Remedy for Comment about pd_fault Behavior

Andrew Gardner

Presentation Objectives

Figure 104–8—PD state diagram

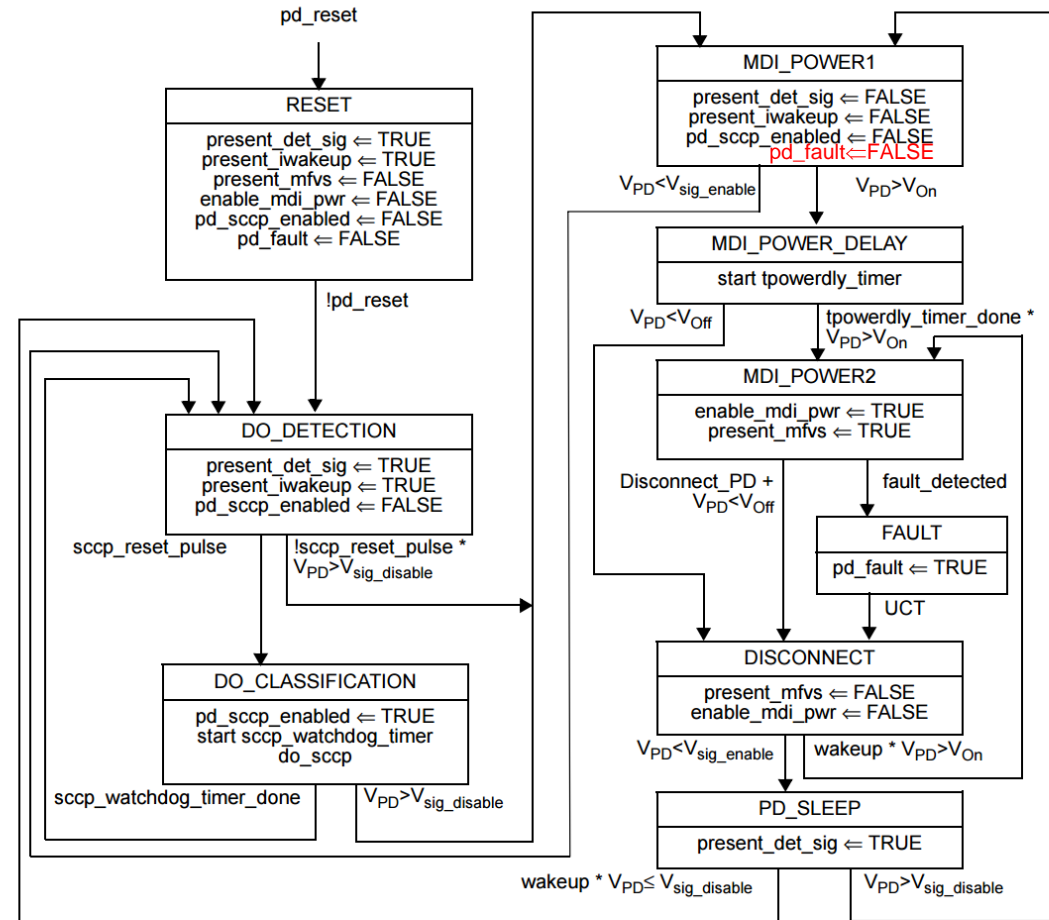
- Currently the `pd_fault` variable is set to `FAULT` only in the `RESET` state.
- Need to add `pd_fault ← FALSE` assignment to a state subsequent to `DO_CLASSIFICATION` so PSE can check for a persistent fault condition by cycling the voltage at the PI through $V_{sig_disable}$.
- Propose adding `pd_fault ← FALSE` assignment to the `MDI_POWER1` state.

Editor: make change to Figure 104-8 shown in red.
